CCF 190577
ORD-19-16175
COM-ADD-19-00059

Certificate of Appropriateness

1327 E. BRADY ST. Brady Street HD

PTS ID 114801 COA: addition and rehabilitation

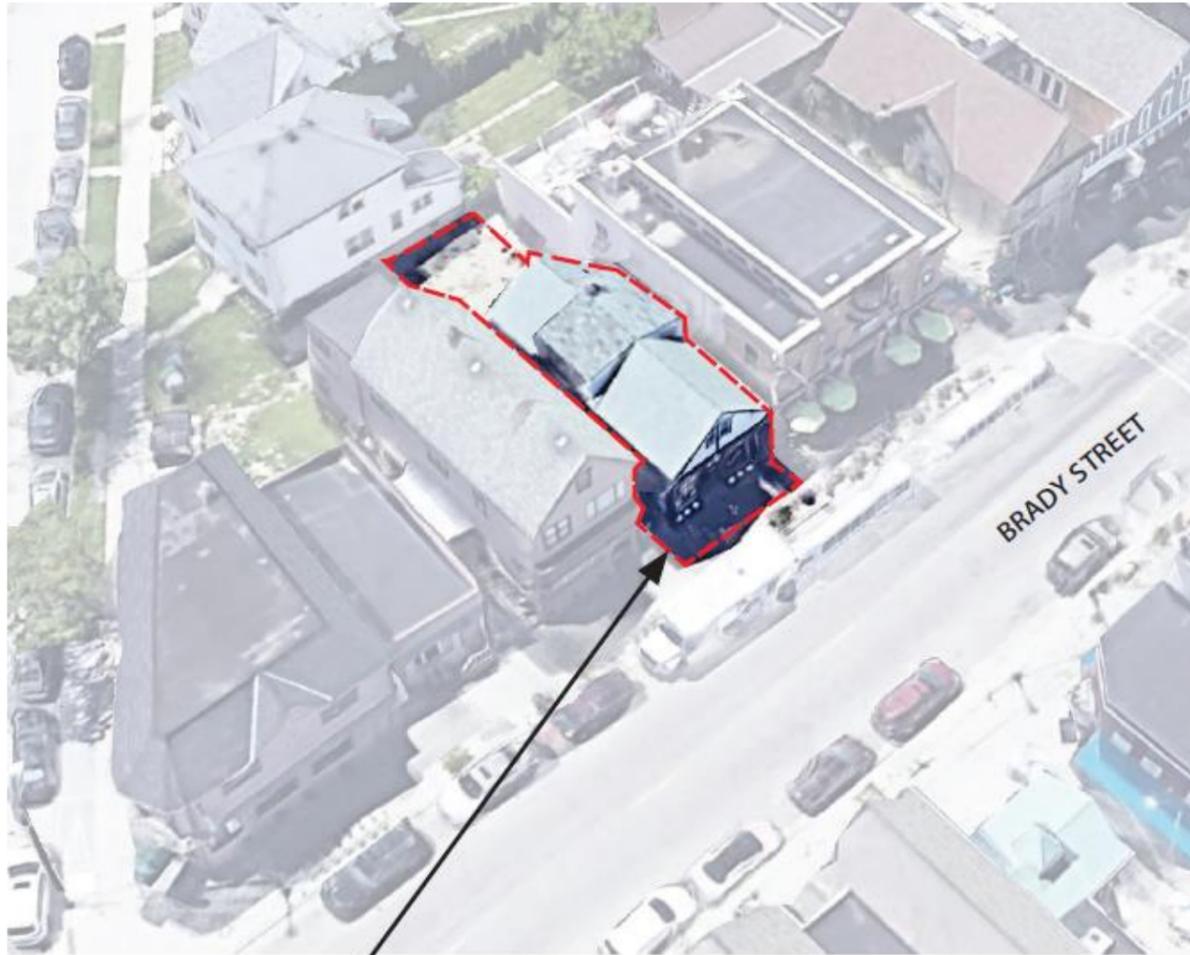
1. New and replacement windows will be all wood both inside and out, except the metal-trimmed storefront glass that is retained. No vinyl, vinyl-clad, aluminum, aluminum-clad or fiberglass windows are permitted. New glass size must match the original glass size. Muntin profiles and sash heights must match originals.
- 2. Jeld-Wen windows MUST use the optional 3.5-inch bottom rail.**
3. Side elevation doors should have some degree of decoration. Wood veneer is required unless there are fire code requirements to use a rated door. Applicant must prove need for fire-rated doors if steel doors are to be used. Traditional four-panel doors are readily available either way (see example acceptable door design below from *Living with History*).

3 EAST ELEVATION - NEW WORK

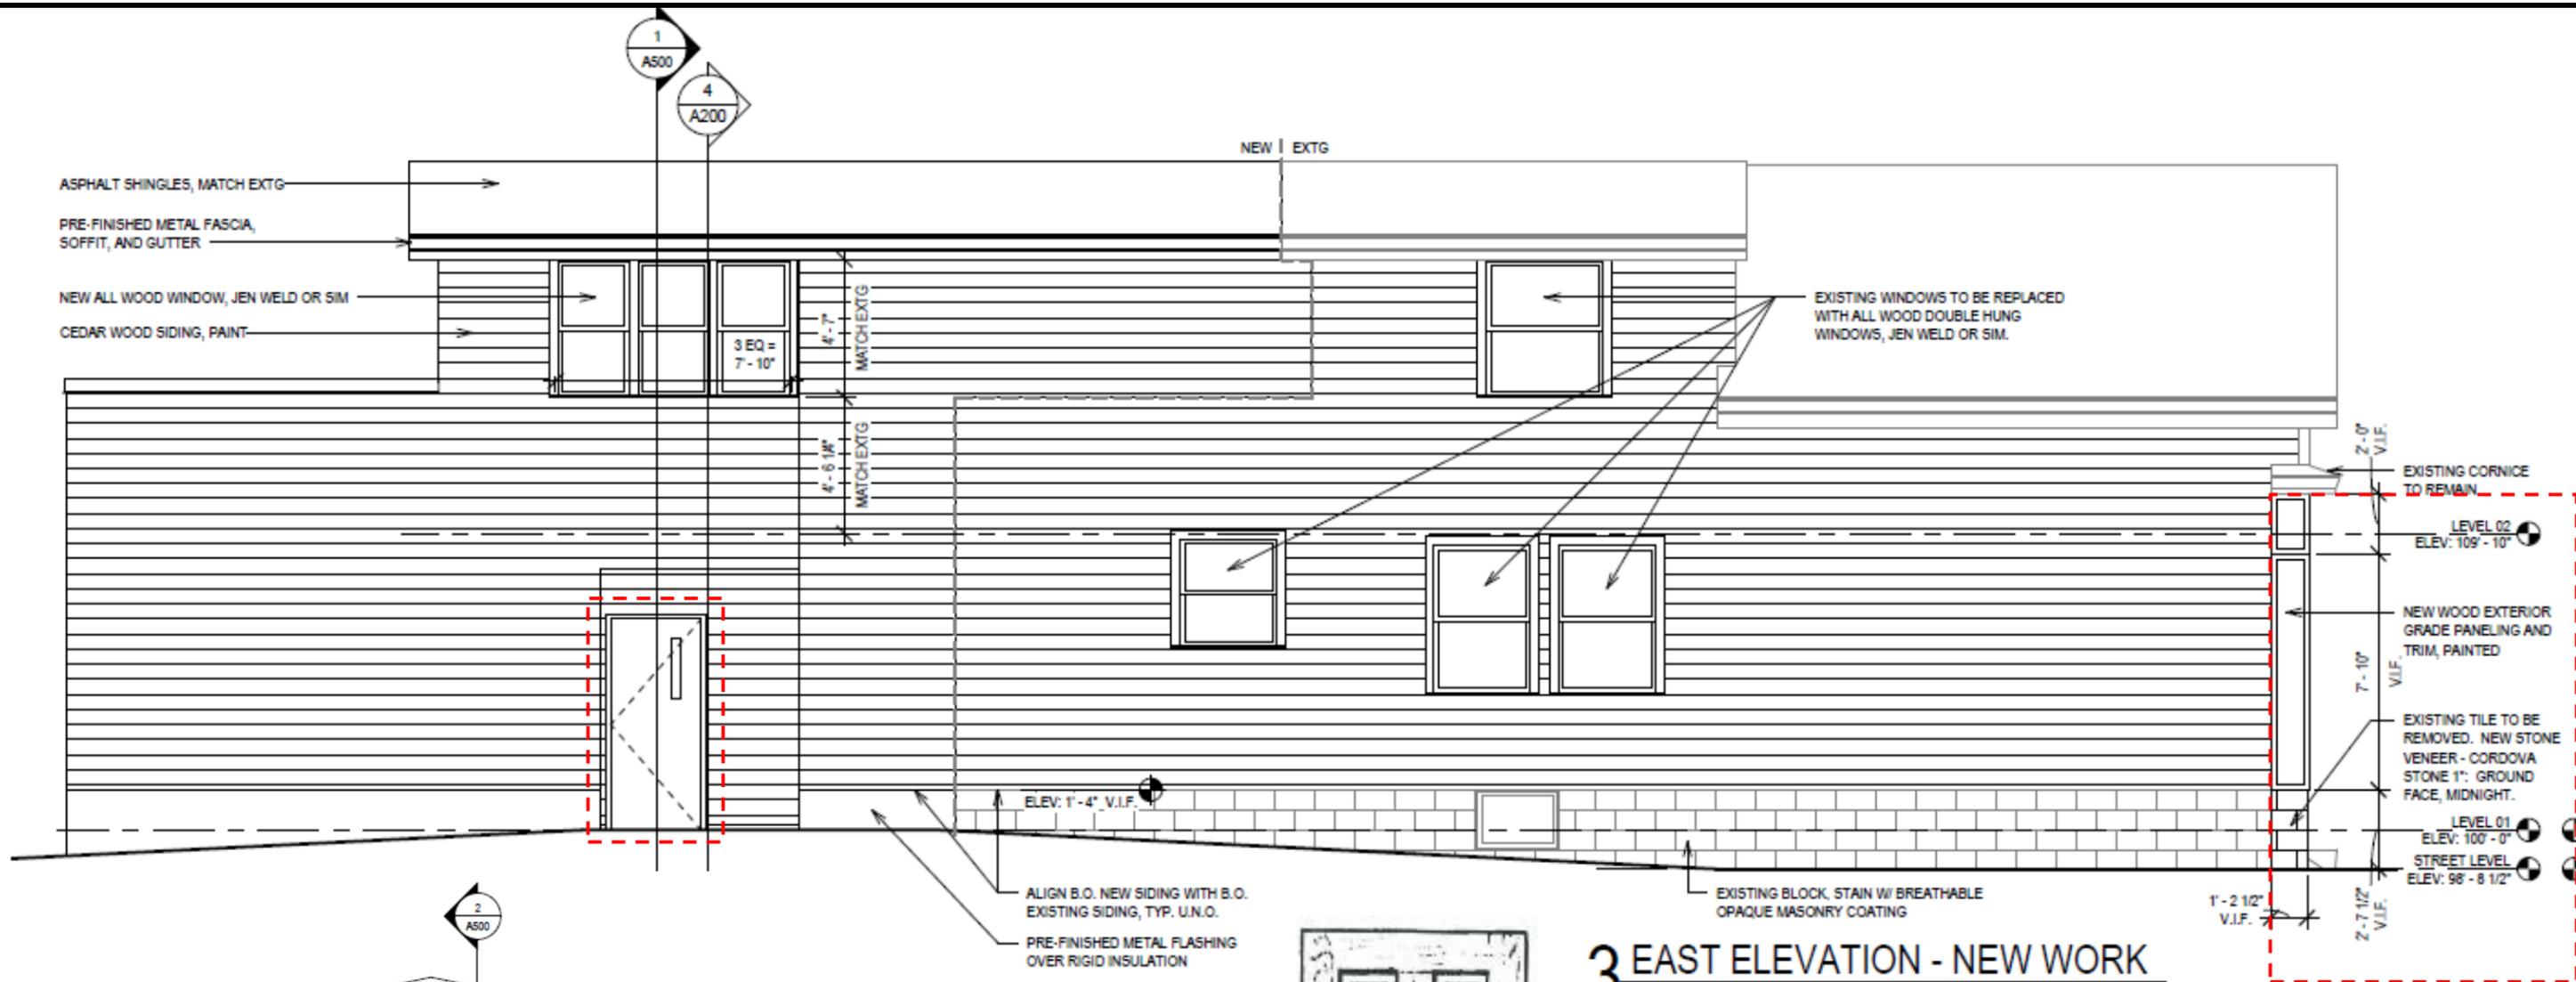
Addition will match the pitch of the existing dormer and carry the roofline throughout

Single story portion at the rear will feature a high parapet to conceal future mechanical

Vinyl siding on the existing structure will be removed to reveal wood siding – to be repaired and replaced as needed and painted to match existing conditions

Addition will be clad in cedar siding to match the existing wood siding

Replacement windows and new windows will be all wood double hung

All styles
1860-1910

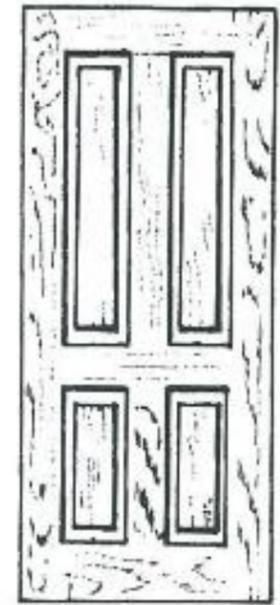
Accessible entrance door MUST match a compatible design from HPC Book *Living with History* (example pictured at left). Other designs are possible upon submission to staff for review. A window or peephole is encouraged.

2 SOUTH ELEVATION - NEW WORK

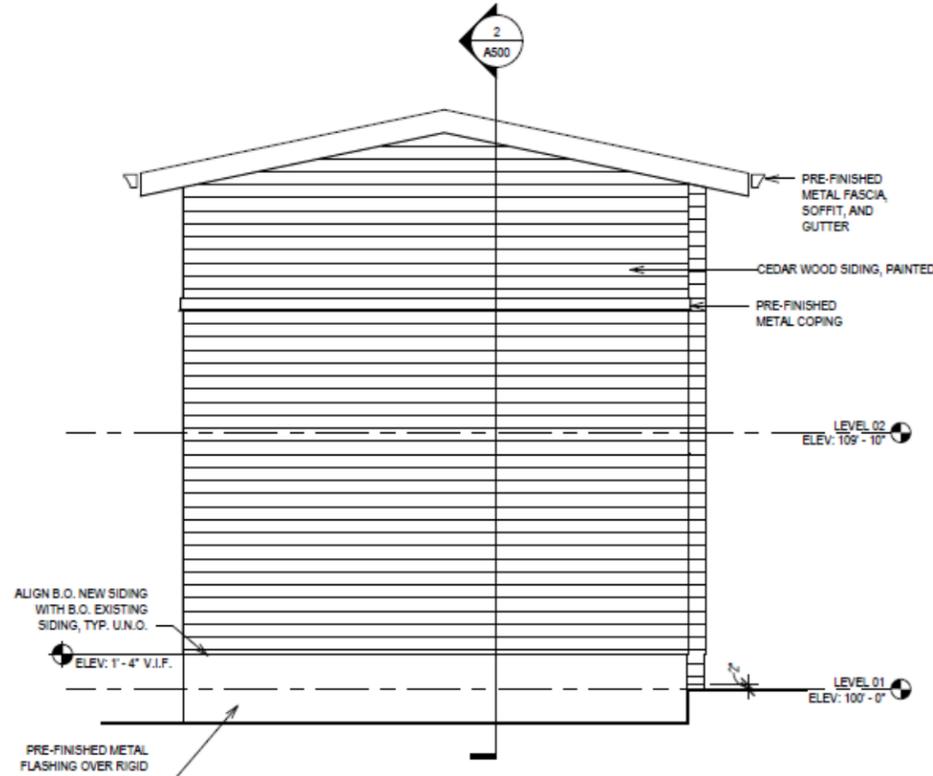
No work will be done on the tile storefront

Vinyl siding on the existing structure will be removed to reveal wood siding – to be repaired and replaced as needed and painted to match existing conditions

Addition will be clad in cedar siding to match the existing wood siding

Replacement windows and new windows will be all wood double hung
